Access Compliance Report

Public Rights-of-Way

Intersection ID: 15205	Main Street: CHEROKEE_RD	Cross Street: FENTON_PL	Location: E
ADA ID: 78EE149E94AB	Ramp Type: Directional1	Initial Pass/Fail: Pass	Overall Compliance: No
		Severity Score: 2.75

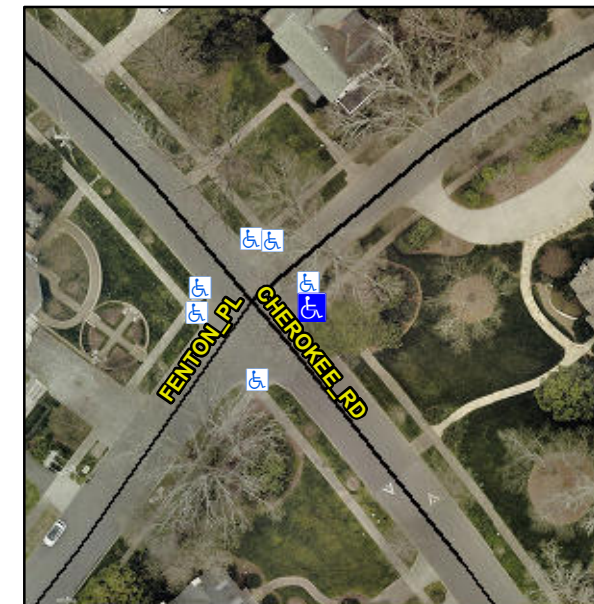
**R304.2.2-Perp, R304.3.2-Para,
R304.5.2, R305.1.4**

Compliance	Description	Data	Compliance	Description	Data
N/A	Ramp Length (in)	78.0	No	Grade Break?	No
Yes	Ramp Width (in)	52.0	N/A	Grade Break Slope (%)	5.4
Yes	Ramp Slope (%)	5.8	N/A	Grade Break XSlope (%)	1.6
Yes	Ramp XSlope (%)	2.2			
N/A	Flare Type LT	N/A	N/A	Flare Type RT	N/A
N/A	Flare Slope LT (%)	11.7	N/A	Flare Slope RT (%)	9.3
N/A	Flare Traversable LT?	No	N/A	Flare Traversable RT?	No
Yes	Landing Length (in)	57.0	Yes	DWS Provided?	Yes
Yes	Landing Width (in)	52.0	Yes	DWS Contrast?	Yes
No	Landing Slope (%)	2.2	Yes	DWS Length (in)	24.0
Yes	Landing X Slope (%)	0.3	No	DWS Full Width?	No
N/A	Landing Curb? (Y/N)	N/A	Yes	DWS Offset LT (in)	1.5
N/A	Shared Landing?	Yes	Yes	DWS Offset RT (in)	4.0
Yes	Gutter Ponding?	No	Yes	Gutter Slope (%)	1.5
Yes	Gutter Lip Ht (in)	0.0	Yes	Gutter X Slope (%)	2.0
N/A	Painted X Walk1?	No		Road Slope (%)	4.4
	X Walk 1 Direction	To S		Road X Slope (%)	3.9
	X Walk 1 Width (in)	N/A		Clear Space?	Yes

X Walk 1 Slope (%)	4.4	N/A	Clear Space to XWalk (in)	N/A
	X Walk 1 X Slope (%)	3.9	Yes	Storm Grate/Utility Hazard?	No
N/A	Ramp inside XWalk1?	N/A		Storm Grate/Utility Type	
Yes	Any Obstructions?	No			N/A
	Obstruction Type		Yes	Surface Condition? (G/P)	Good
			N/A	Curb Slope (%)	5.4

Remove & Replace Entire Ramp.
